PLANNING, ZONING, & BUILDING DEPARTMENT  
PZ&B Staff Combination Memorandum: Architectural Commission and Town Council

SUBJECT: ZON-23-061 (ARC-23-074) 100 WORTH AVE (COMBO)

MEETING: JUNE 28, 2023 ARCOM  
JULY 12, 2023, TC

**ORIGINAL SITE PLAN**

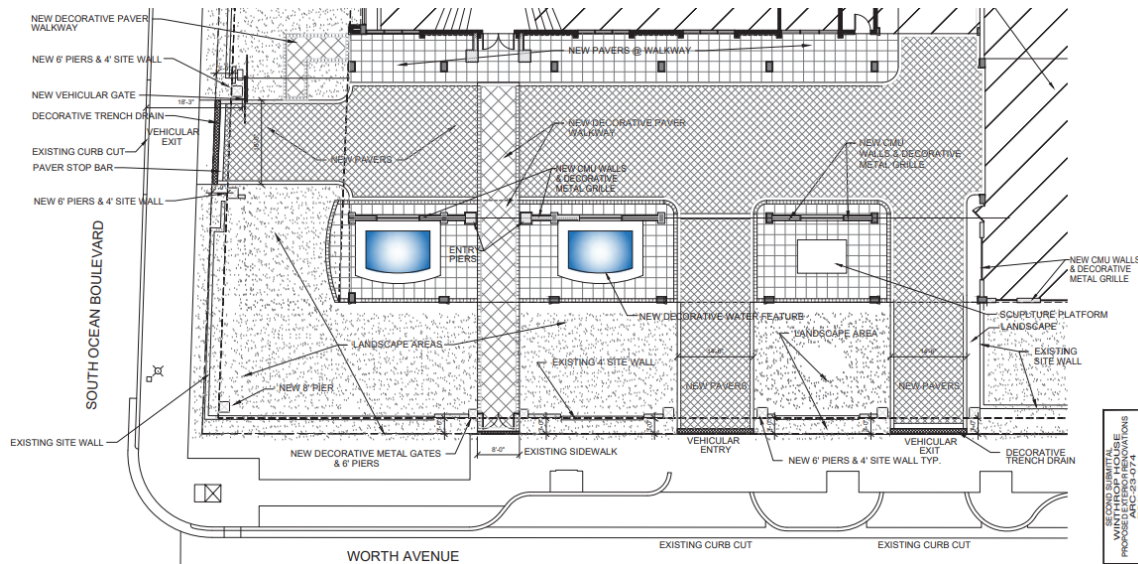
The request for the variance relief is to improve the existing front yard open space conditions along Worth Avenue and South Ocean Boulevard by removing hardscape consisting of driveway motor court and what appears to be nonconforming partaking areas and replace those areas with natural landscape areas. If approved, the proposal would increase the overall landscape open space by 2%, or 2,000 SF; which is not an easy achievement in the sitework of an existing 8-story building built in 1970. The landscape improvements to the site will not include any vegetation greater than 30-inches within sight lines. The Public Works Department has reviewed the proposal and has no outstanding issues regarding the removal of drive aisles and the installation of the vehicular gate. The Fire Department has reviewed the proposal and has no outstanding issues regarding the

removal of drive aisles and the installation of the vehicular gate.

The existing 8-story building is nonconforming as it pertains to the current parking requirements, and the elimination of five of these will result in a furtherance of the nonconforming nature. The Code requires 2 spaces per unit + 1 per 5 for guests for a total of: 121 units x 2 = 242 + 25 guest spots = 267. Currently the site has the original 251 spaces it was constructed with.

### PROPOSED SITE PLAN

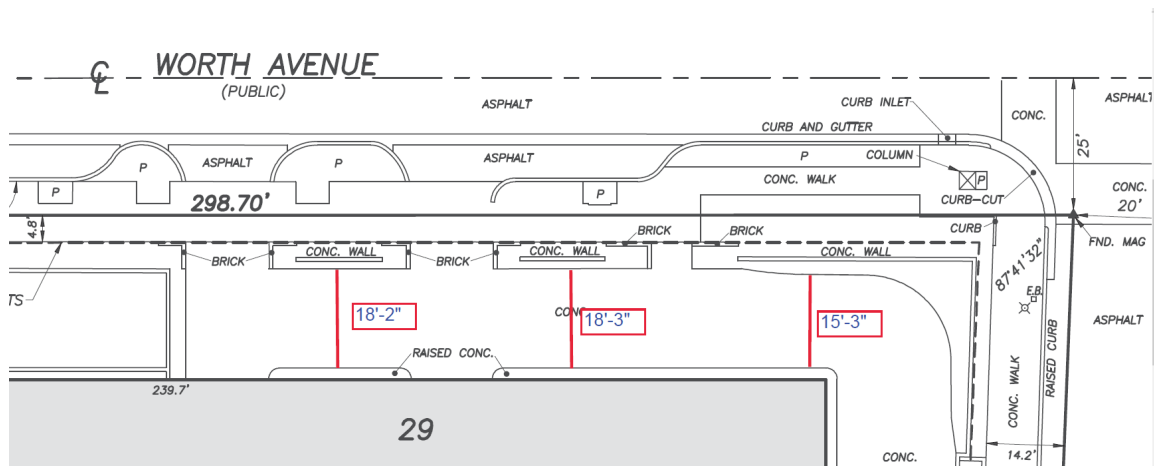
A careful review of the existing conditions, which included a field visit, confirms that the existing 'parking' area, or the hardscape area along the southeast corner of the subject property does not have sufficient width to provide both a one-way drive aisle (12') and parallel parking space (10') which is what the existing conditions recite. As such, to retain the existing conditions albeit with a new ground hardscape material would trigger variances that would be in contravention to life safety as it pertains to vehicular traffic flow.

Staff does have some concerns that the area does provide an adequate temporary loading and delivery space for the building. The applicant maintains that the site is currently overparked and that the 246 spaces that will remain is more than adequate for the needs of the building.
